**RE: Blythe Energy Transmission Line Project Request for Staff Approved Project Modification (99-AFC-8C)**

## **Request for Staff-Approved Project Modifications (99-AFC-8C)**

### **Blythe Energy Project Transmission Line Minor Modifications to the Blythe Plant Connection to the Generation Intertie**

### **Drawings Showing General Configuration of Western's Buck Boulevard Substation Before and After Proposed Change**

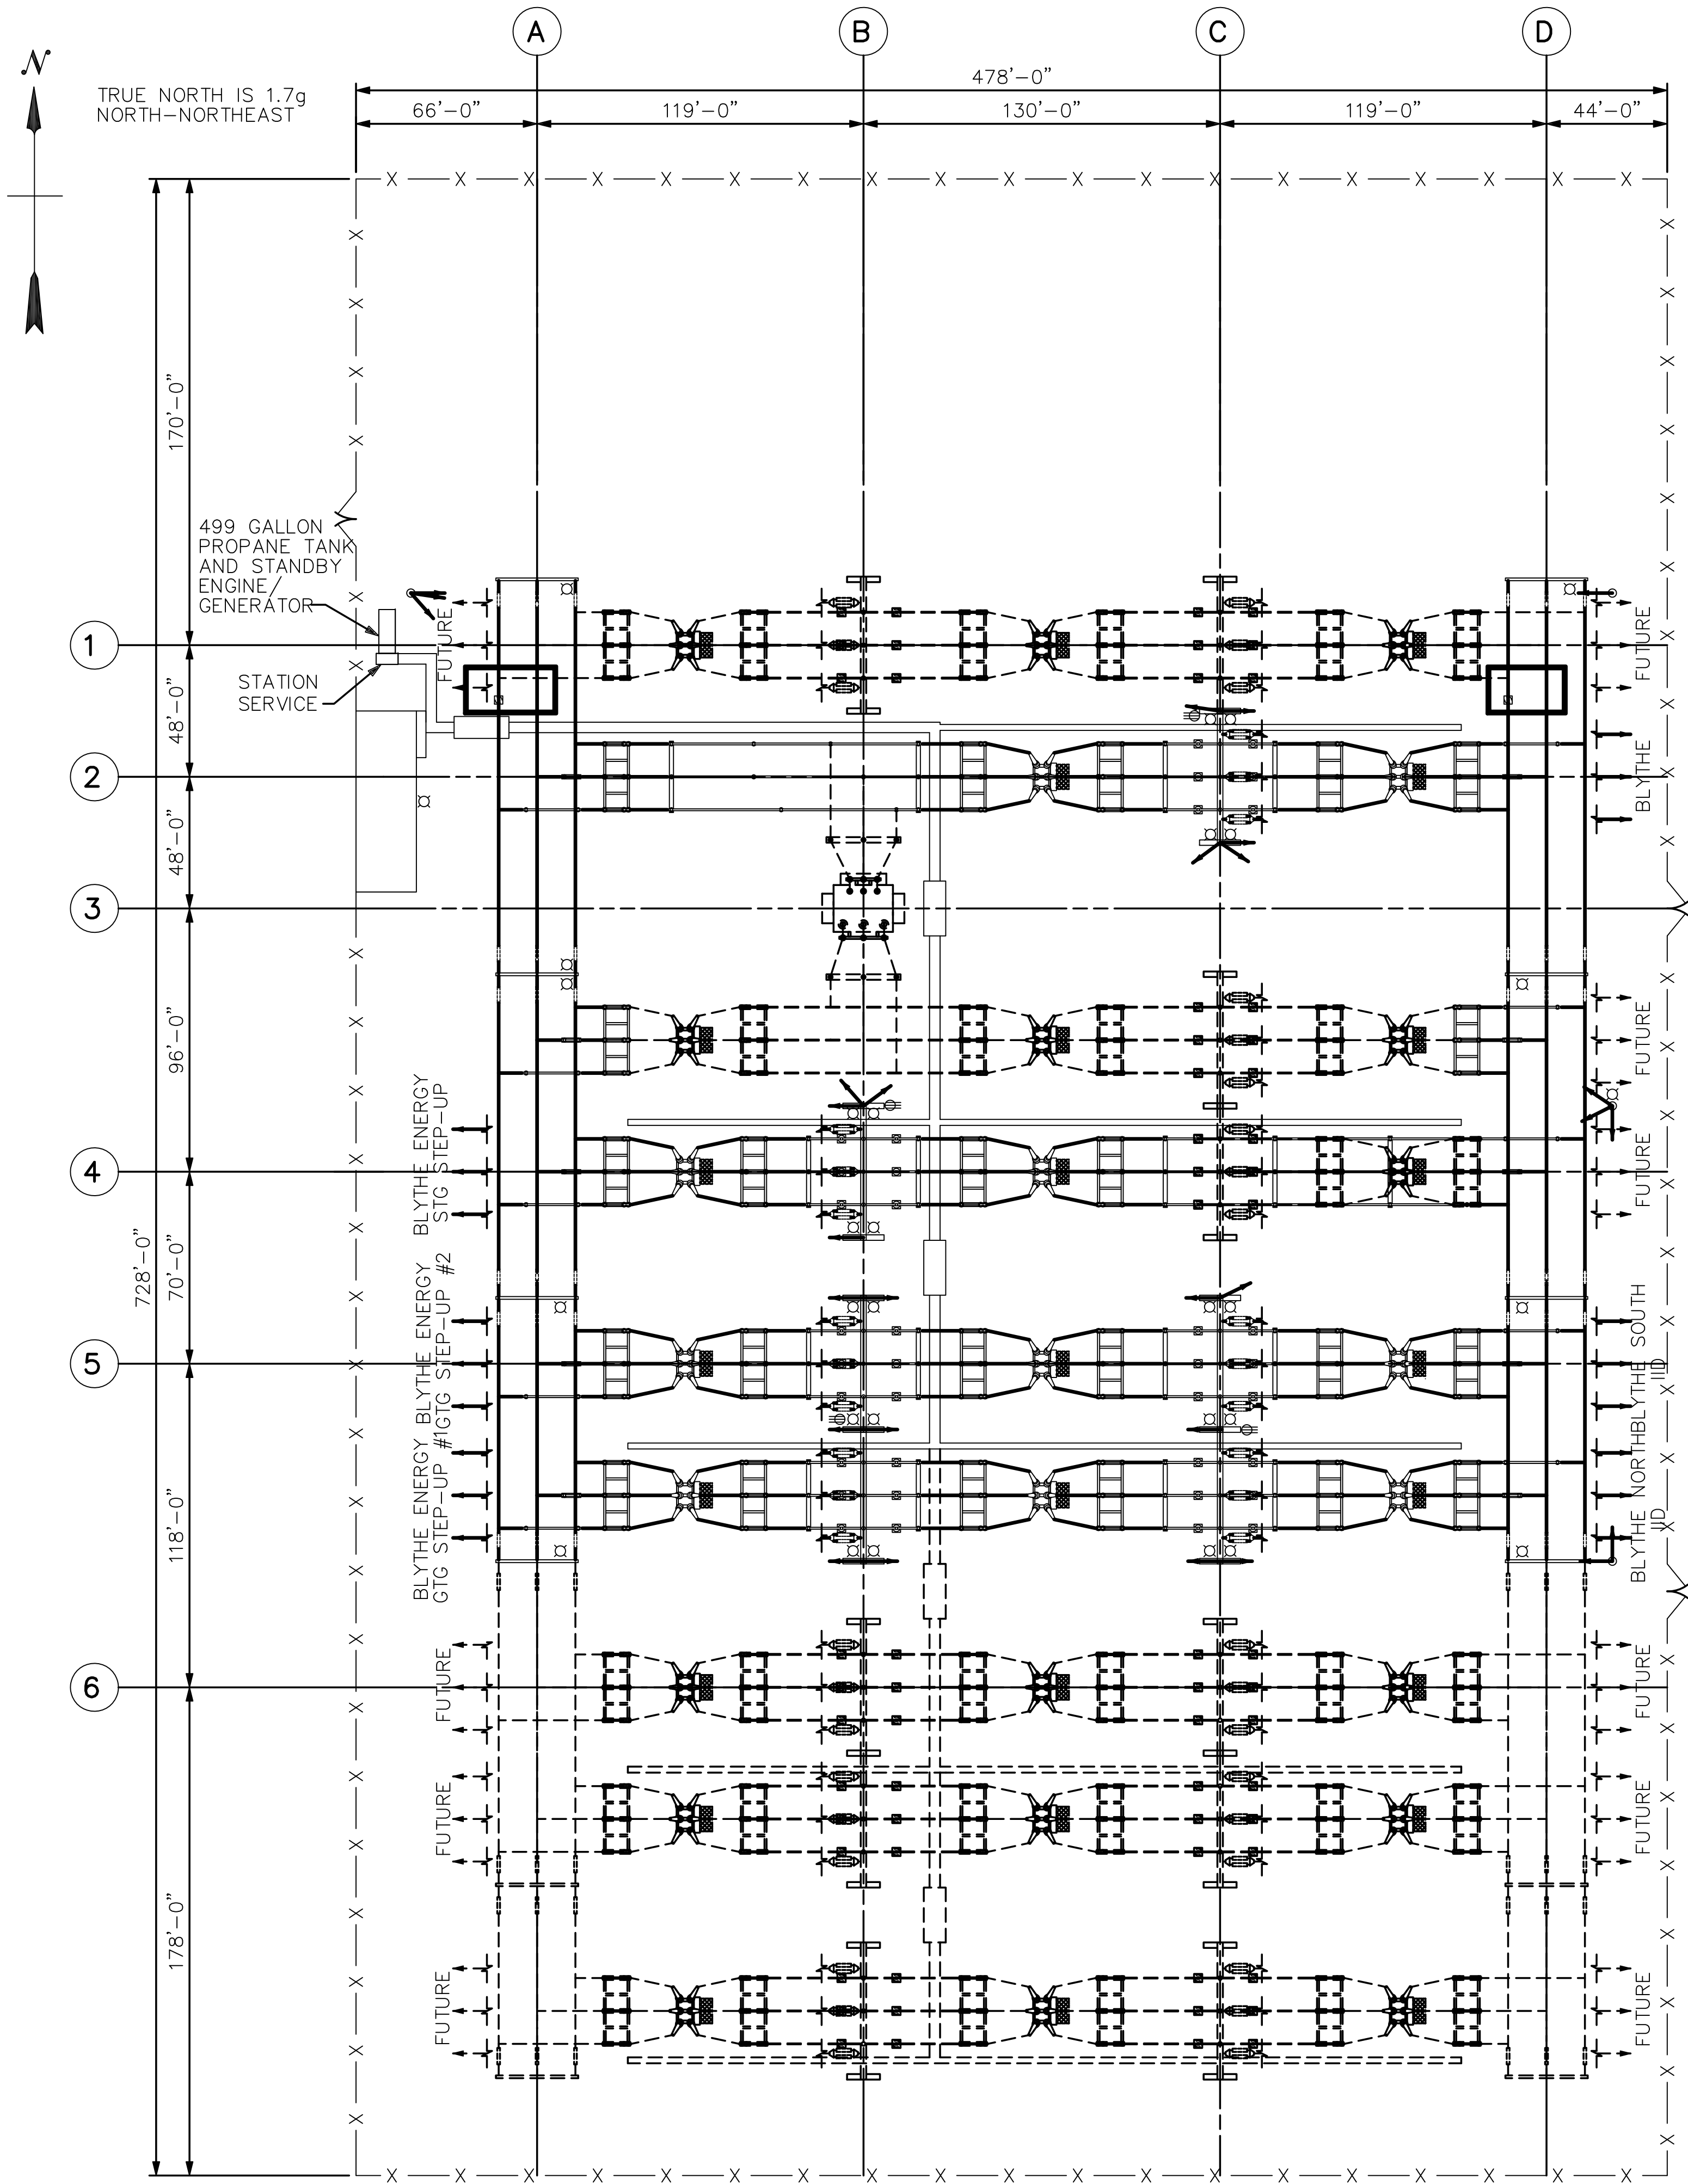
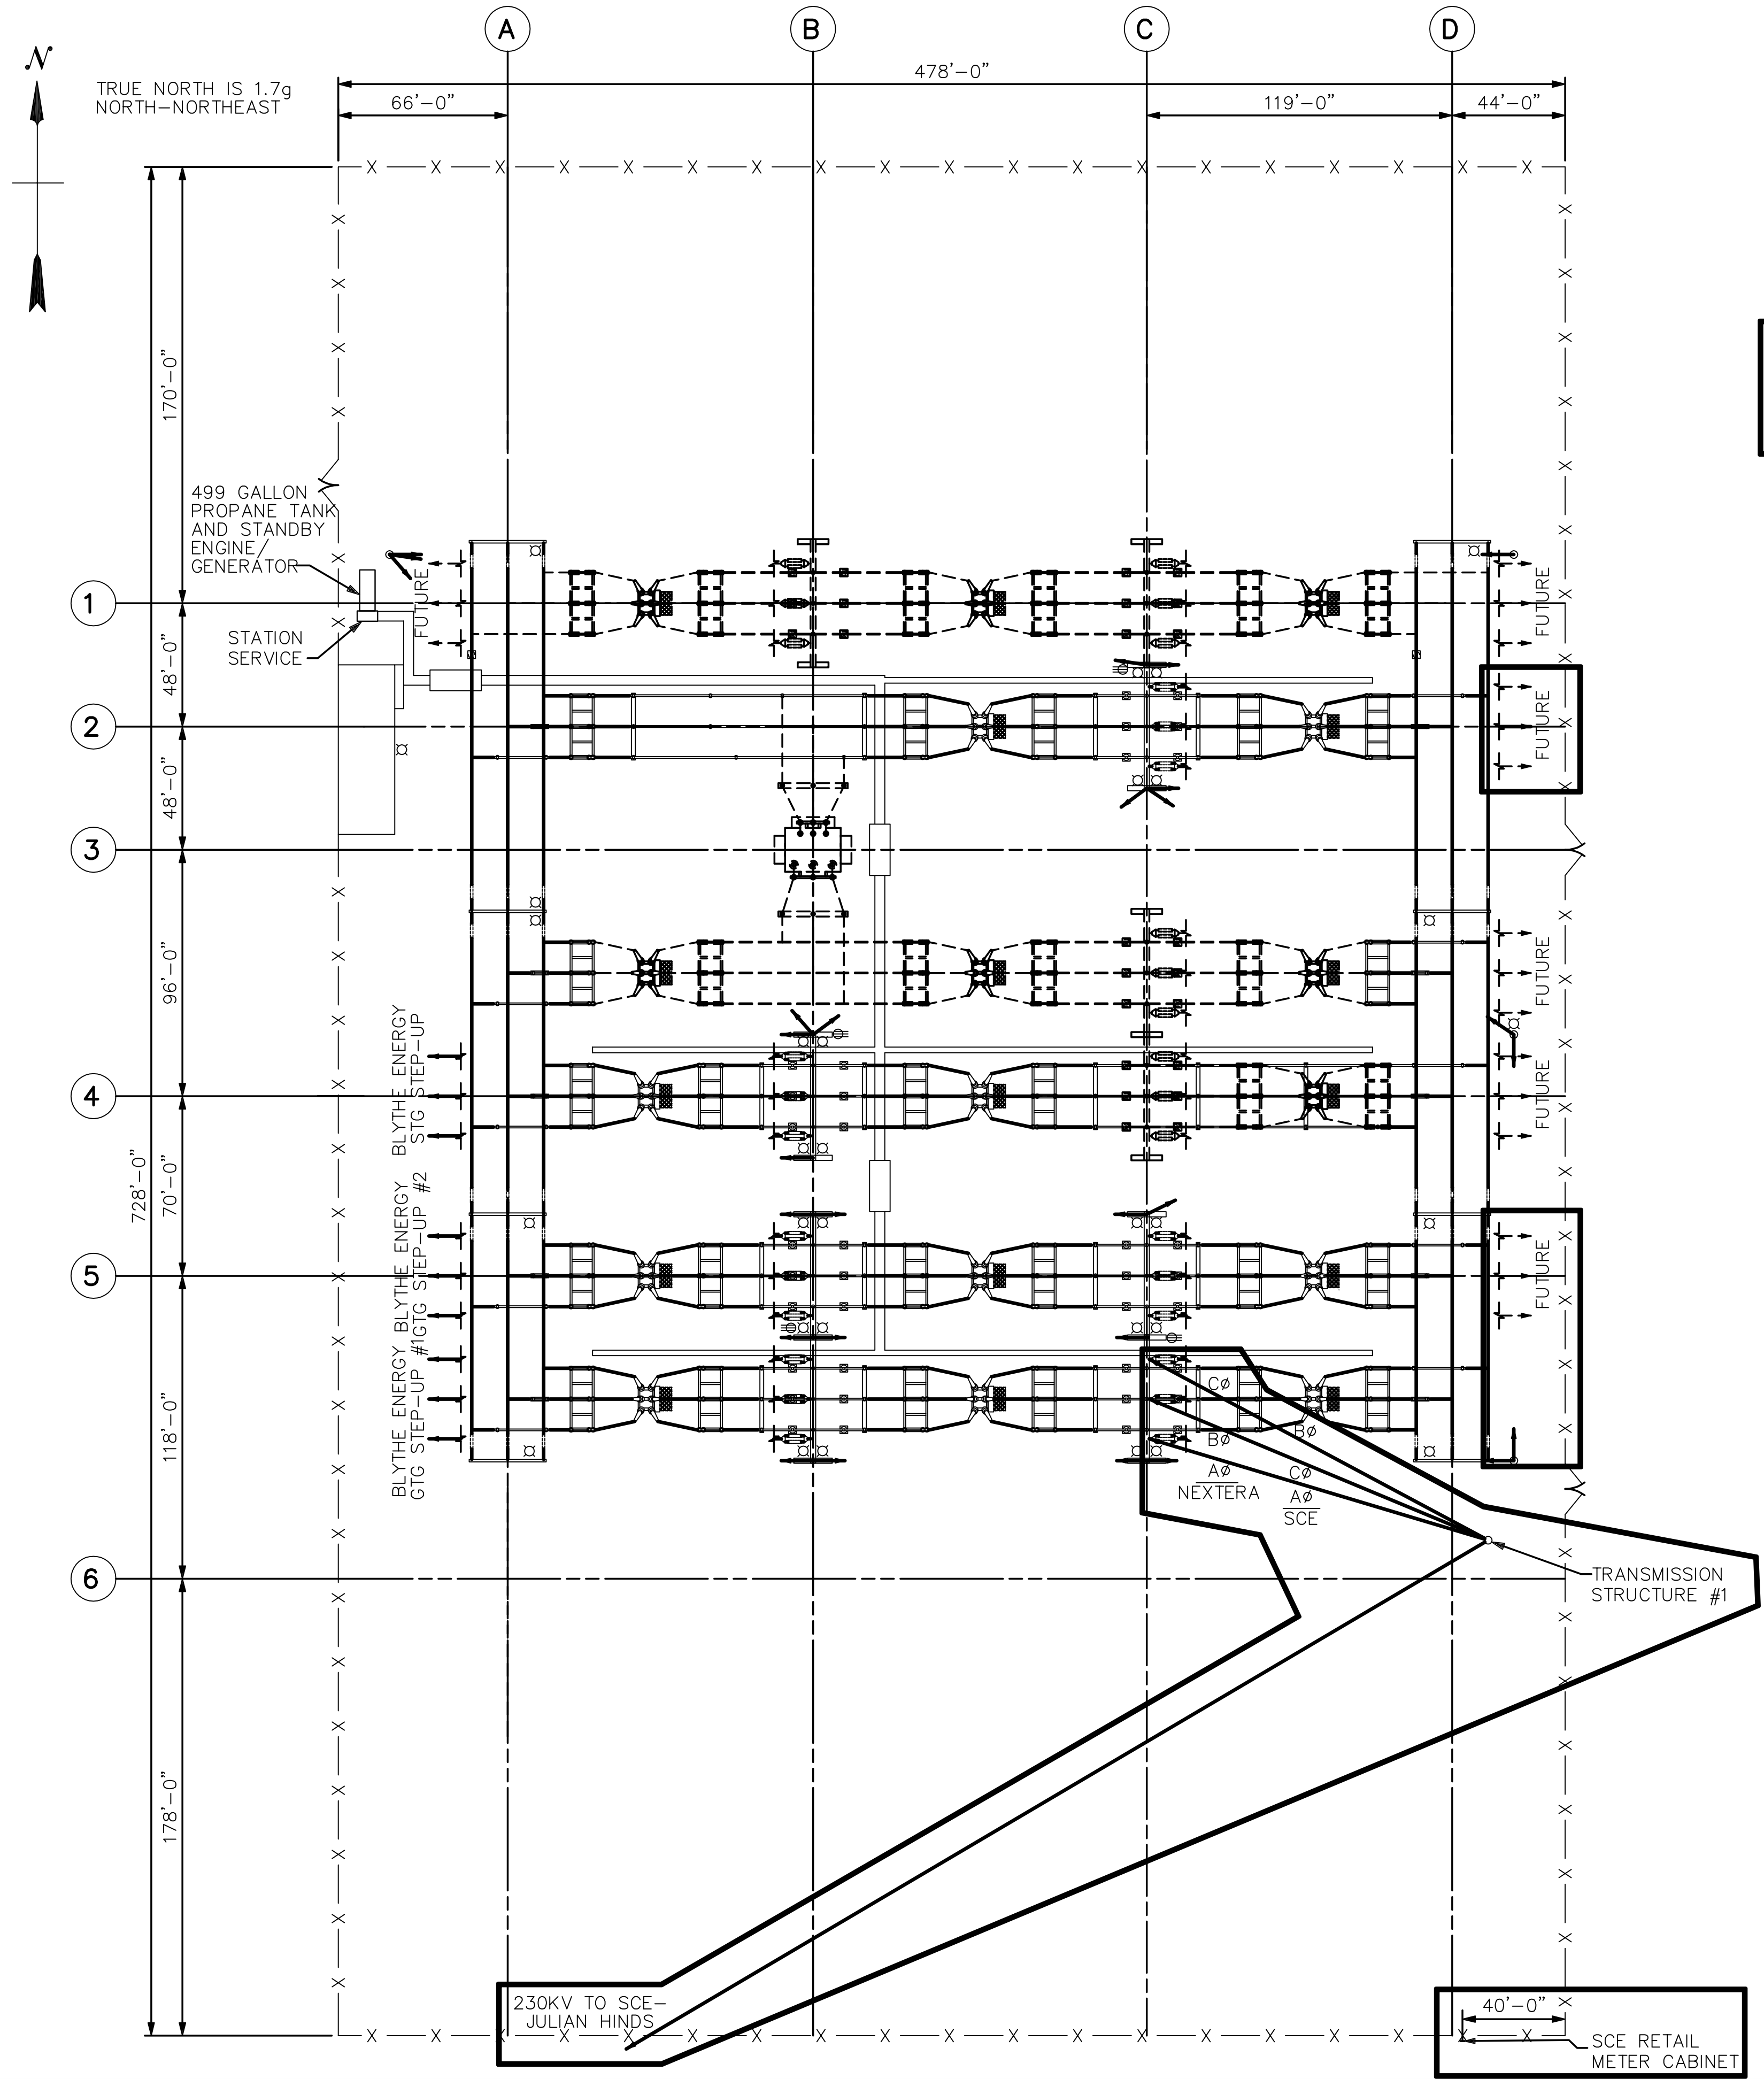
The following describes the steps necessary to finalize the construction and conversion of the Buck Substation from its present connection with the Western system to a direct connection to the SCE system through the BEPTL. Appendix B includes drawings showing the general configuration of the Buck Substation before and after the proposed change. The work will be performed during two plant outages. The first plant outage is scheduled to begin February 27, 2010, lasting through April 5, 2010, to conduct an upgrade to their DCS system. The second will be in June 2010 and will last up to 25 days.

With CTG1 electrically isolated from the Western operating grid and CTG2 and STG1, electrical conductors will be installed from Transmission Structure #2, to Transmission Structure #1, and finally to the Buck Substation bus (drawing BKB 1000, Appendix C). This will provide the electrical connection from the SCE (indicated as Julian Hinds in drawing BKB 0001, Appendix C) operating grid to the Buck Substation. The portion of the Buck Substation connecting CTG1 to the SCE operating grid will be ready for operation at 230 kV at this time.

# HOW TO CHANGE THE VOLTAGE RATING FROM 161kV OPERATION TO 230kV OPERATION (260MVA TRANSFORMER)

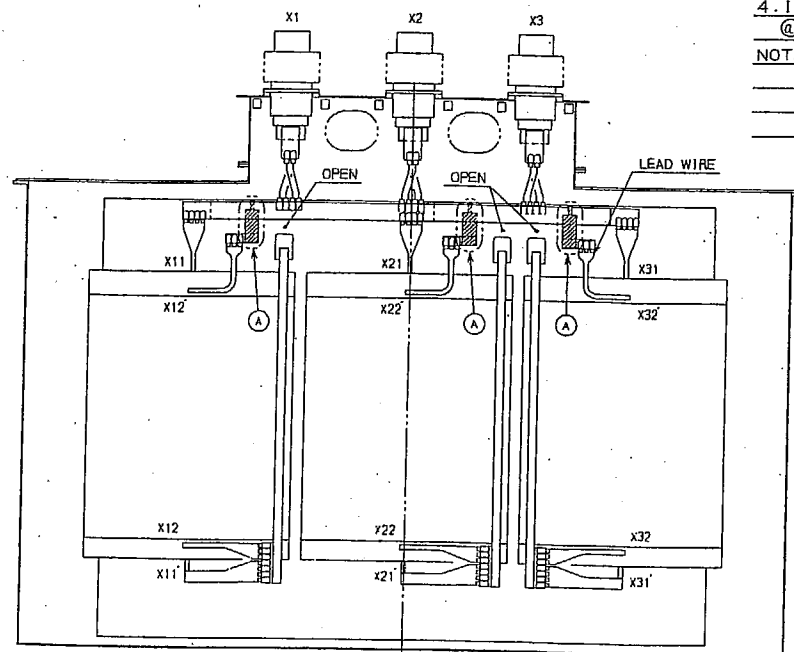
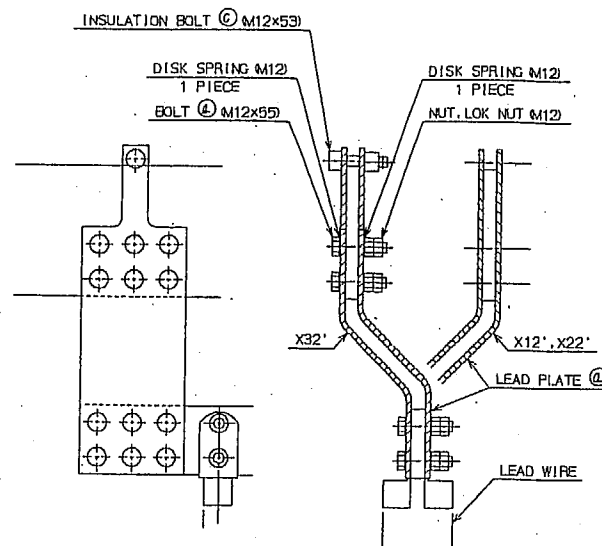
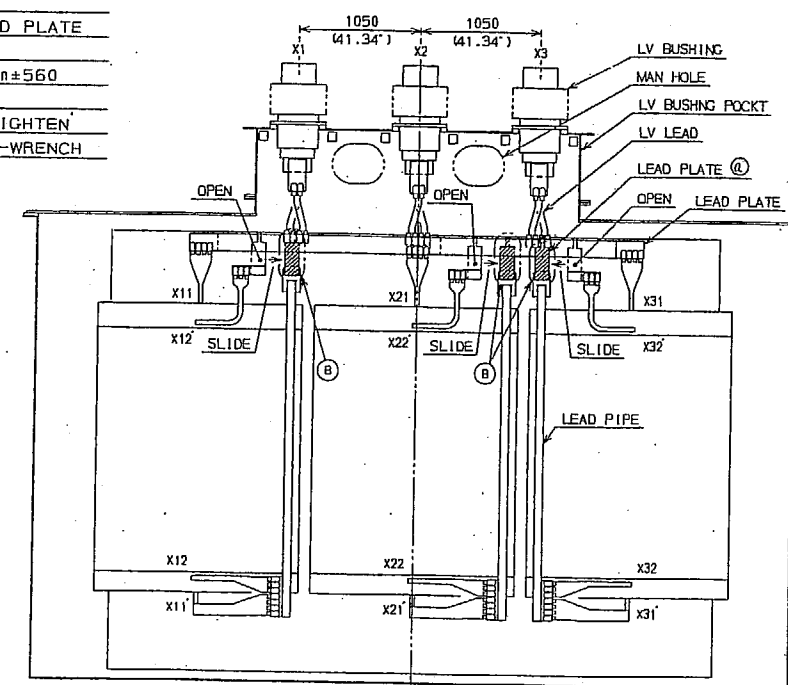
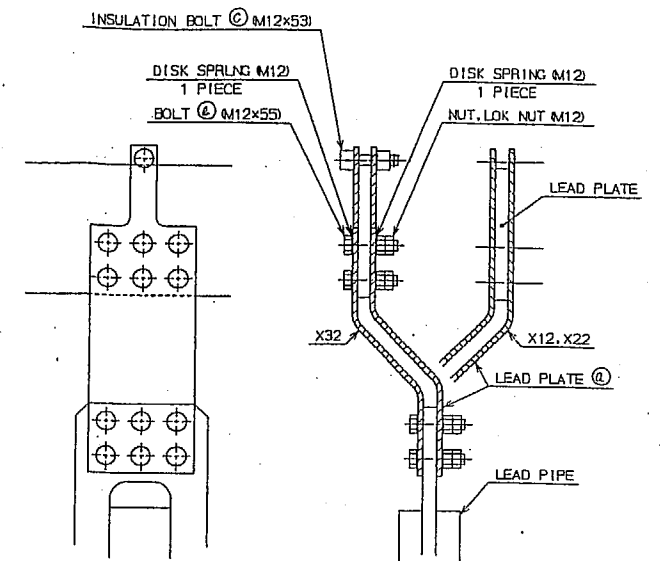
The step-up transformers that transform the voltage generated by the Blythe Energy Plant at 16 kV to 161 kV and connect to the Buck Substation are dual-rated transformers. Each of the three step-up transformers can be converted from 161 kV to 230 kV. This conversion is completed by changing connections internal to the transformer.

*Transformer Voltage Shift*—While the electrical conductors are being installed during the second plant outage, the step-up transformer connected to CTG1 will be converted from 161-kV to 230-kV operations. This work will require that approximately 16,500 gallons of insulating fluid be removed from the transformer's tank. This is required to gain access to the connections that need to be changed to make the voltage conversion inside the transformer. The fluid removed from the transformer will be contained in up to three commercial tanker vehicles. Each vehicle will be temporarily parked next to the transformers during fluid transfer, and then driven off-site while the electrical connections are switched. A Construction Spill Prevention, Containment, and Countermeasures (SPCC) Plan for project construction has been developed to address the transformer fluid transfer (further details below and in Appendix D). The transformer tank will then be vacuum treated and refilled with the insulating fluid. After refilling the transformer, acceptance testing will be performed. Upon successfully completing the tests, the step-up transformer for CTG1 will be energized at 230 kV and capable of back feeding the plant with 16-kV service. The total time to convert the step-up transformer for CGT1 is estimated to be seven days. Once the conversion is completed, CTG1 will not be in operation and the plant-critical auxiliary power will be supplied by CTG2 and STG1.

1. 12 BOLTS (A) ON LEAD PLATE (A) ARE TAKEN OUT
2. INSULATION BOLT (B) ON THE TOP OF LEAD PLATE (A) IS LOOSEN WITHOUT TAKING OUT
3. LEAD PLATE (A) IS SLIDED TO SIDEWAYS X12'-X12, X22'-X22, X32'-X32 AND IS TIGHTEN BY BOLT (A) (SHOWN ON LV LEAD WIRING DWG.)
4. INSULATION BOLT (B) ON THE TOP OF LEAD PLATE (A) IS TIGHTEN AGAIN
